SITE PLAN APPROVAL  
 DISTRICT RA3D USE SFD  
 PERMITS 3  
 4191 De C. Higgins

DETERFIELD SUBDIVISION

STEPHENSON BUILDERS INC.

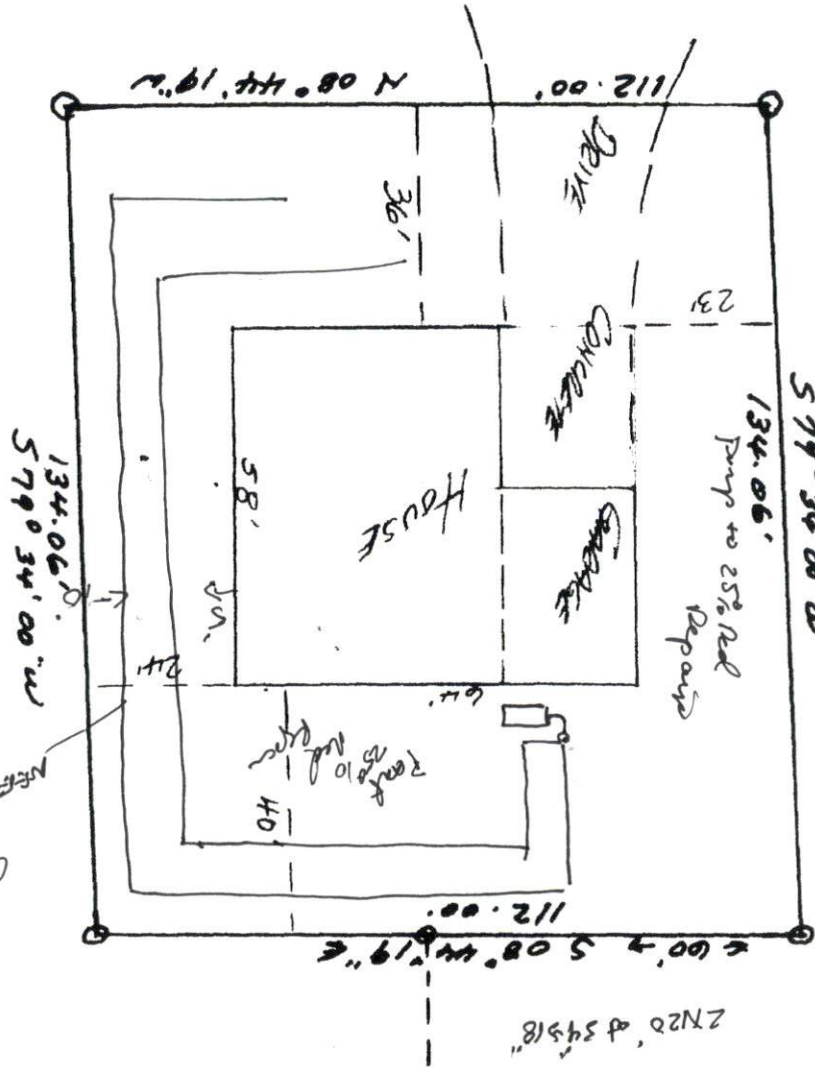
NEED 30' FROM STREETS  
 CALL PHIL  
 28' ←
